Executive Director's Recommendation

Commission Meeting: July 10, 2025

PROJECT Capital One Arena Improvements 601 F Street, NW Washington, DC	NCPC FILE NUMBER 8617
	NCPC MAP FILE NUMBER 21.10(38.00)46006
SUBMITTED BY District of Columbia Office of the Deputy Mayor for Planning and Economic Development	APPLICANT'S REQUEST Approval of preliminary site and building plans
REVIEW AUTHORITY District Projects in the Central Area per 40 U.S.C. § 8722(b)(1) and (e)	PROPOSED ACTION Approve preliminary site and building plans
	ACTION ITEM TYPE Staff Presentation

Proposed Metro Entrance Changes

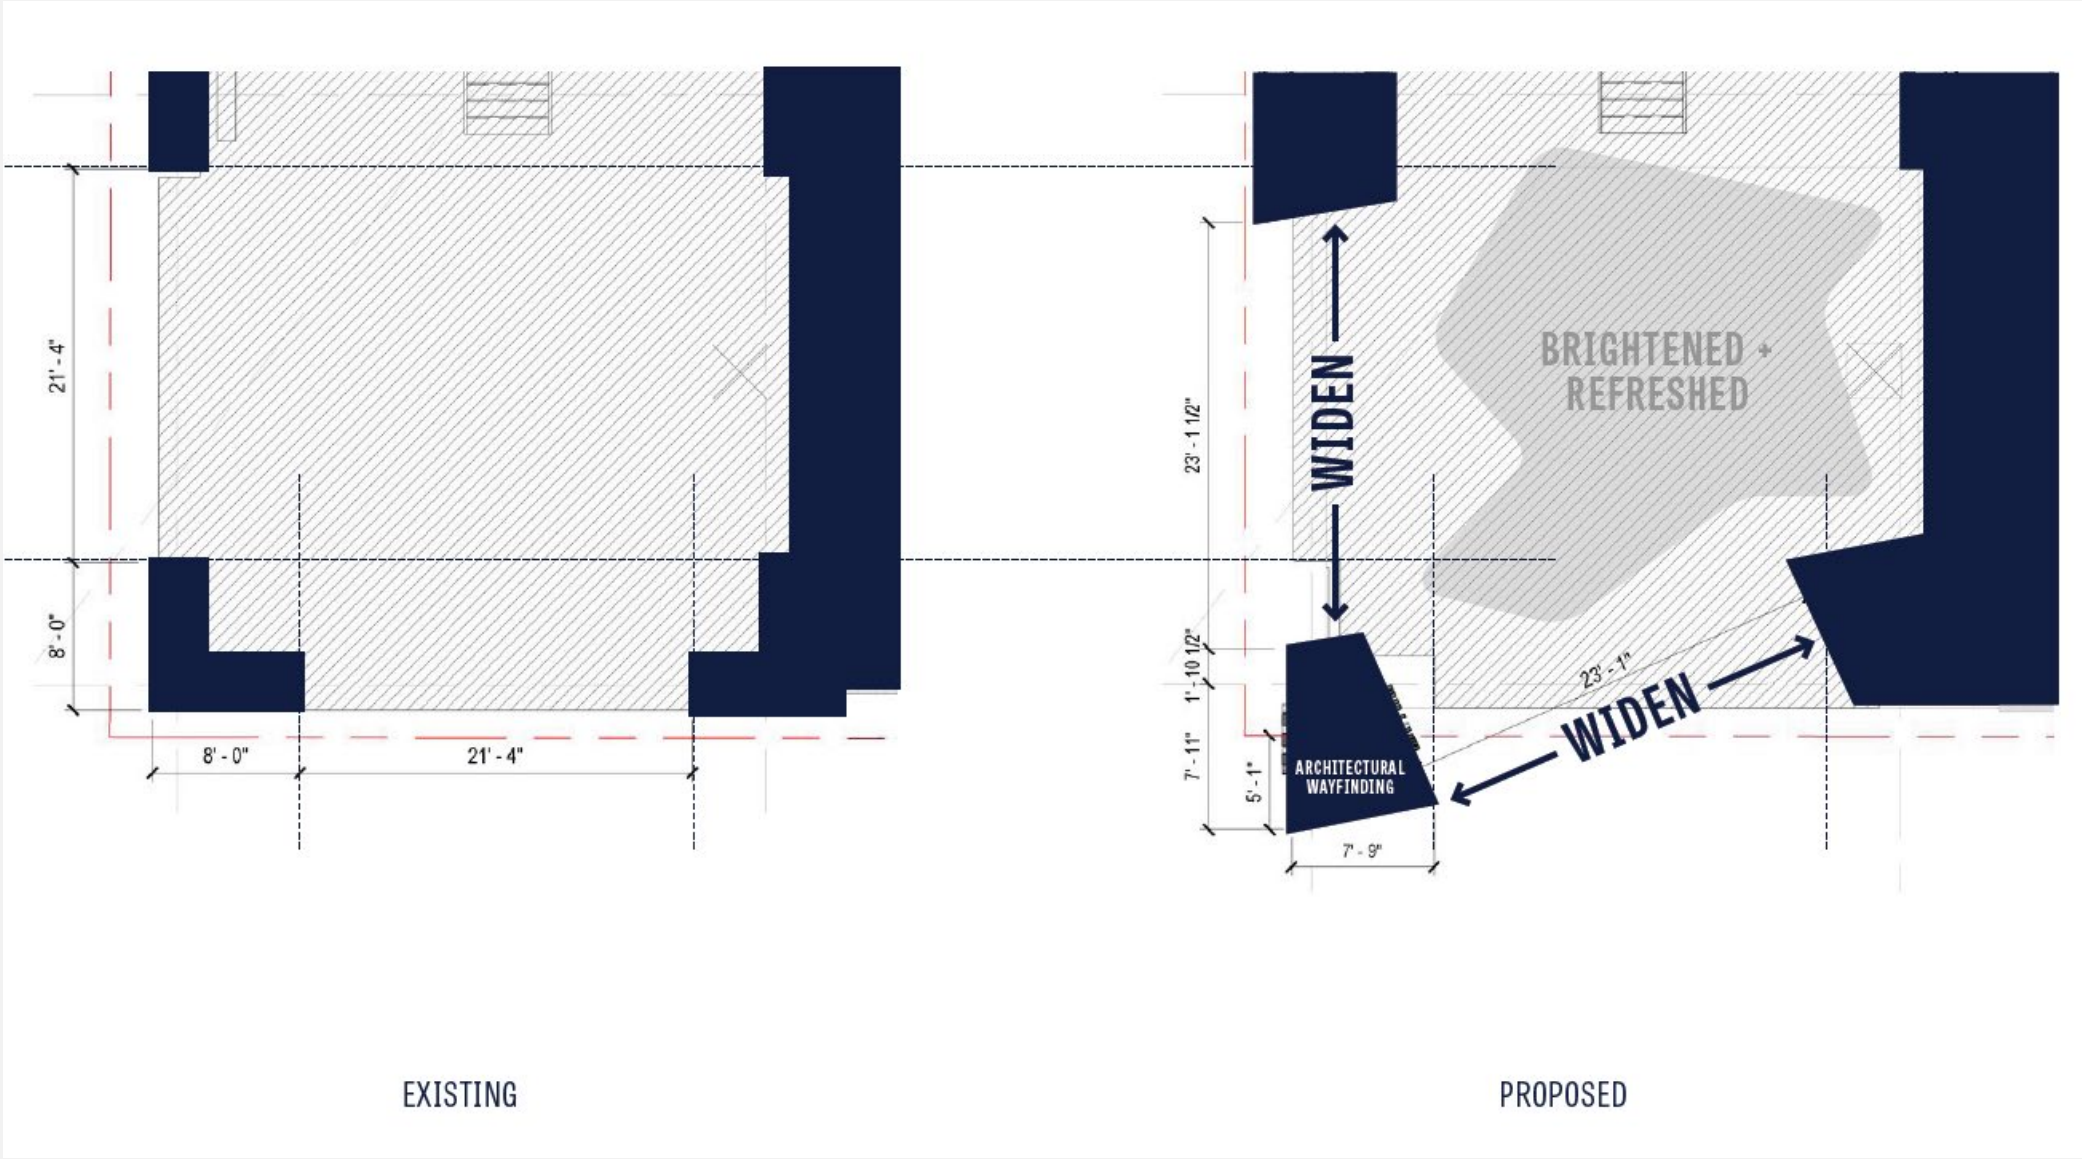
Requests the applicant coordinate with the Washington Metropolitan Area Transit Authority regarding the proposed Metrorail Station entrance/exit.

The applicant has made some minor changes to improve the existing Metro entrance at the corner of 7th and F Streets. The two openings have been widening and the façade at the corner has been pushed out into the sidewalk as architectural wayfinding. The plans also note that the covered area of the Metro entrance will be brightened and refreshed. Staff supports appropriate modifications to improve access and wayfinding, but recommends the **Commission request the applicant coordinate with the Washington Metropolitan Area Transit Authority regarding the proposed Metrorail Station entrance/exit.**

Proposed Elevations

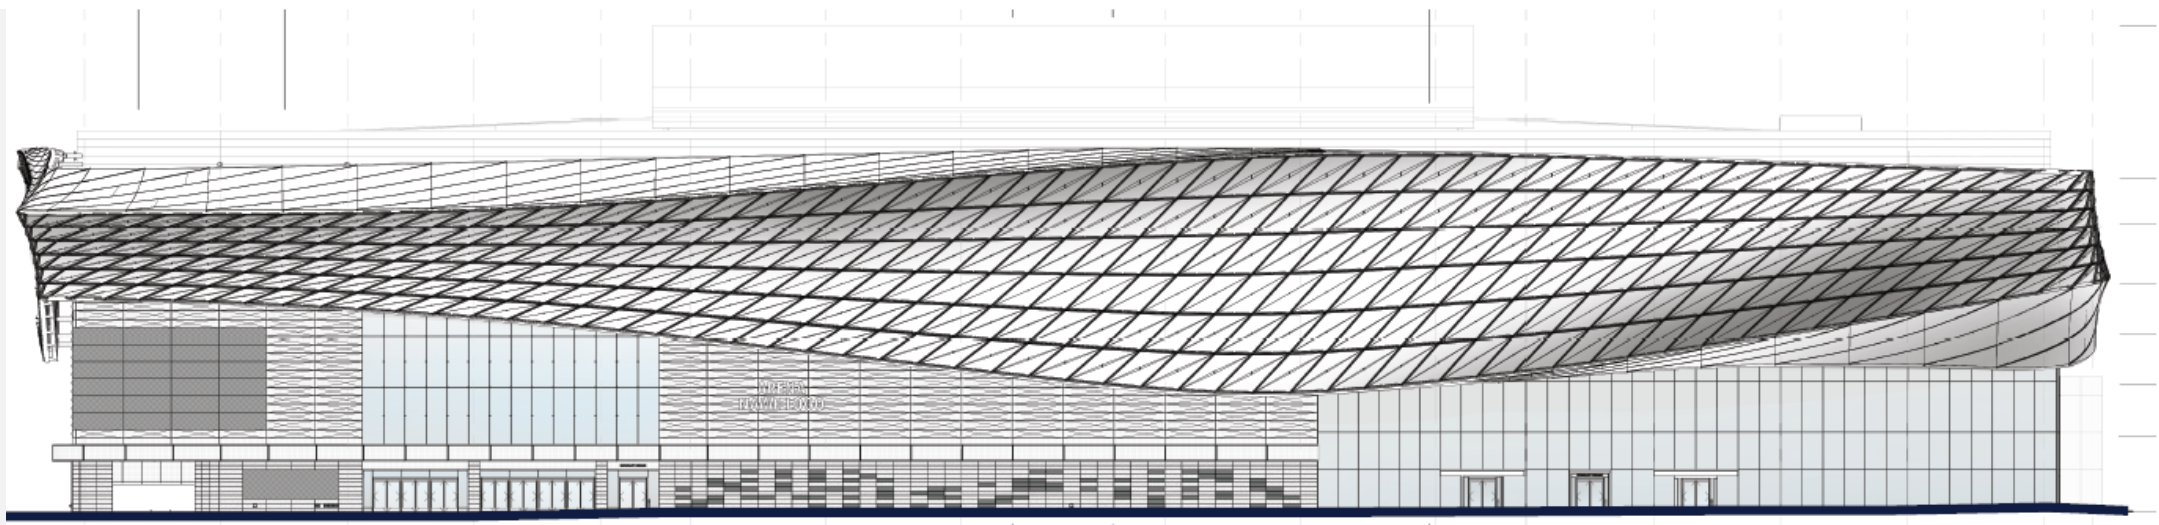
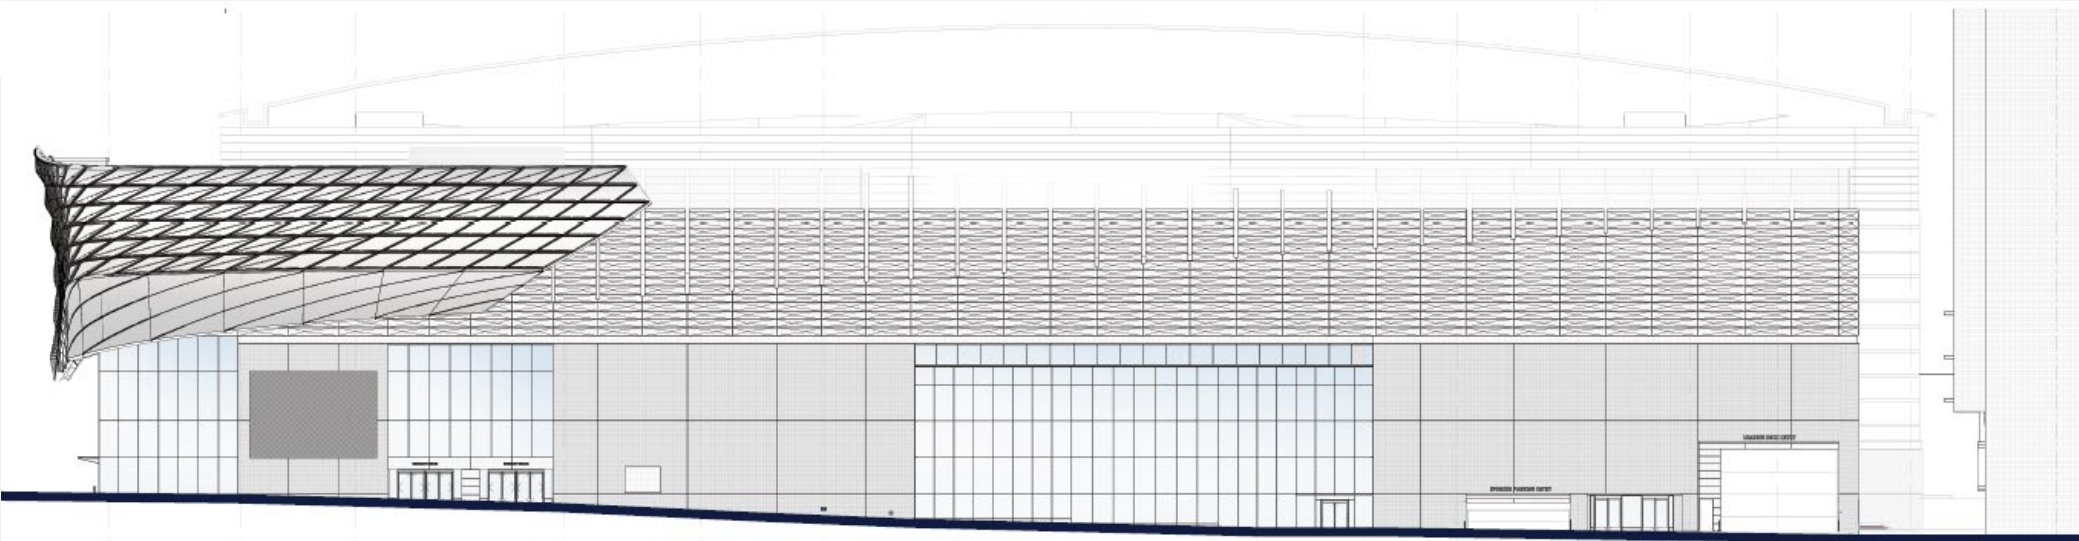
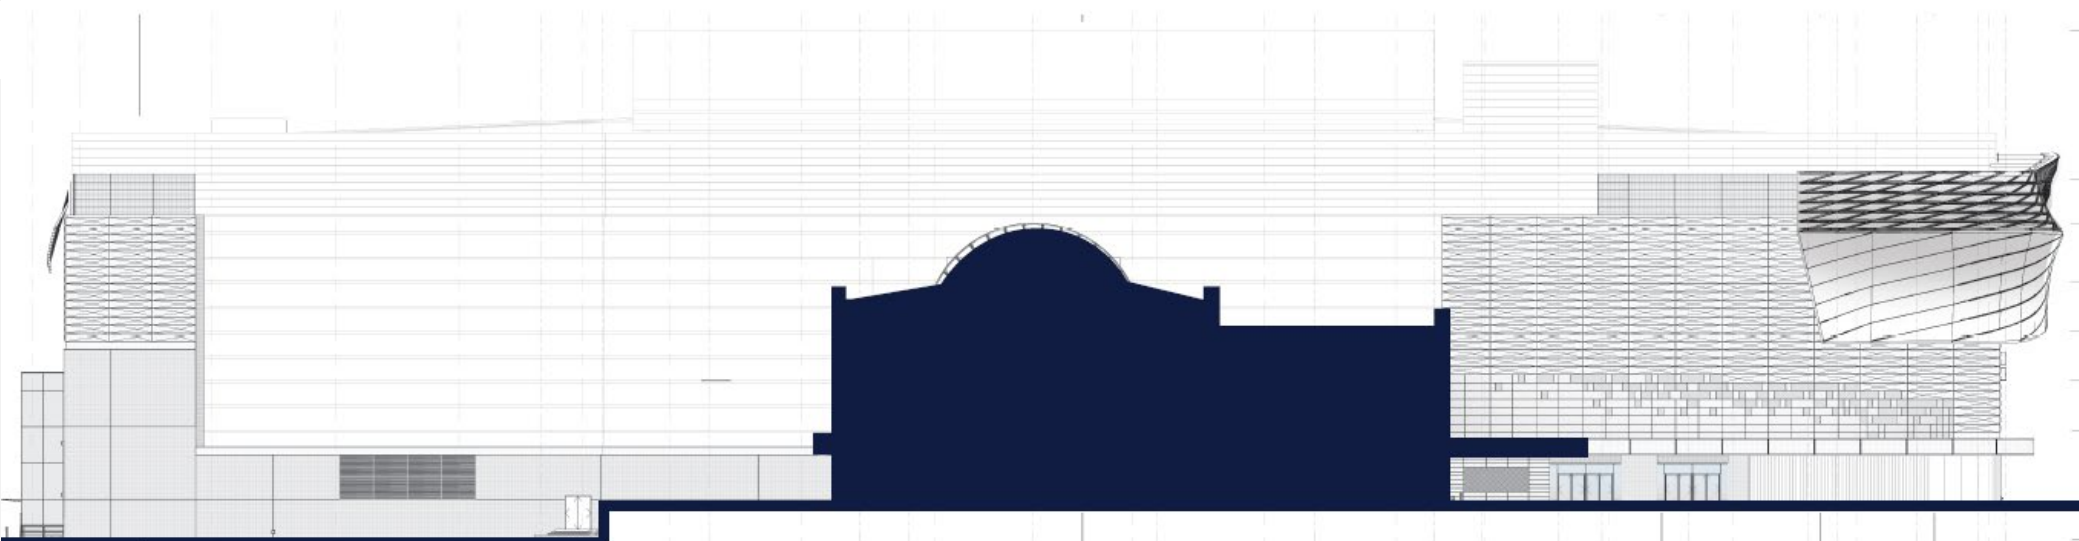
Notes that due to structural limitations, the applicant determined extending the veil along 6th Street was not feasible. As such, the applicant proposes to extend the idea of the veil through the use of other design elements

Supports conceptually extending the veil on 6th Street through design elements like the framing, and **recommends** the applicant continue to refine the design to reinforce the sense of movement and connection to the veil.

Requests the applicant further evaluate the street level treatment of the façade along 6th Street to also ensure it is engaging for pedestrians.

On 6th Street, the applicant evaluated whether the veil could extend along the entire length of the façade. The applicant determined this is not possible due to significant structural requirements and limitations due the Metrorail tunnel which passes below this portion of the building. In particular, the applicant is limited by the structural foundation of the existing arena, and the challenges of strengthening the subgrade foundation in order to accommodate the additional lateral and wind load of the veil. The applicant is further constrained by the presence of the Red Line tunnel, which runs diagonal through the arena site and just south of the new entrance proposed on 6th Street. The presence of the tunnel makes the necessary structural reinforcements complex and time consuming. Instead, the applicant is proposing façade embellishment to transition the veil to another façade treatment that mimics the movement and dynamism of the veil to better unify this side of the arena with the F and 7th Street facades. Staff believes this change is an improvement and the applicant should continue to refine the design before final review. As such, staff recommends the **Commission express support for conceptually extending the veil on 6th Street through design elements like the framing, and recommends the applicant continue to refine the design to reinforce the sense of movement and connection to the veil.** In addition, staff recommends the **Commission requests the applicant further evaluate the street level treatment of the façade along 6th Street to also ensure it is engaging for pedestrians.**
